DESCRIPTIVE REPORT

Registry No. **H-11202**

General Locality **Approaches to Prince William Sound**

Revisions Compiled During Office Processing and Certification

Figure 1 H11202 Survey Limits

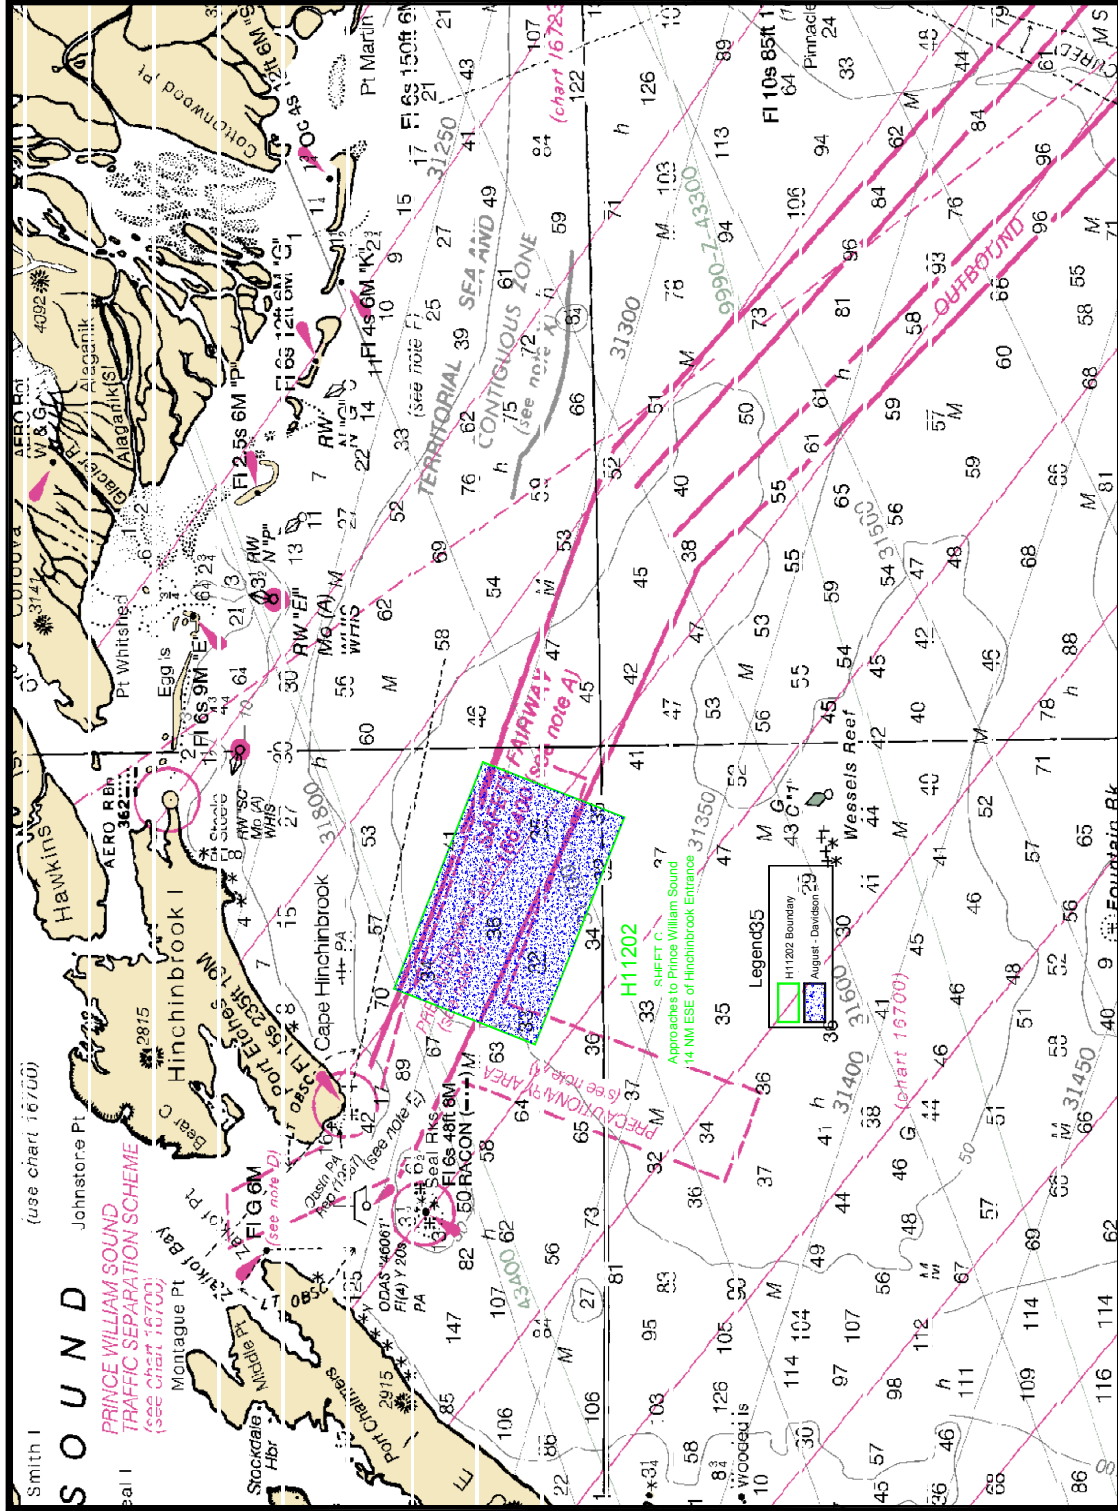
- ¹ Revise sheet limits to the following:
 - 60/11/50N, 146/24/59W (North)
 - 60/06/48N, 146/00/25W (East)
 - 59/59/53N, 146/06/05W (South)
 - 60/05/00N, 146/30/38W (West)
- ² Filed with the Project Records.
- ³ Concur.
- ⁴ PHB Revision--Strikethrough ~~ESE~~ and insert WNW.
- ⁵ PHB Revision--Strikethrough ~~NW corner~~ and insert SW corner.
- ⁶ PHB Revision--Strikethrough ~~WNW~~ and insert ESE.
- ⁷ Concur.
- ⁸ Filed with the Project Records.
- ⁹ Concur.
- ¹⁰ Concur with hydrographer's statements
- ¹¹ Concur.
- ¹² Concur.
- ¹³ Concur.
- ¹⁴ Concur.
- ¹⁵ Concur with clarification. Some bottom samples were retained from Charts 16700. Chart bottoms samples as shown on the Hdrawing.
- ¹⁶ Filed with the Project Records.
- ¹⁷ Filed with the Project Records.
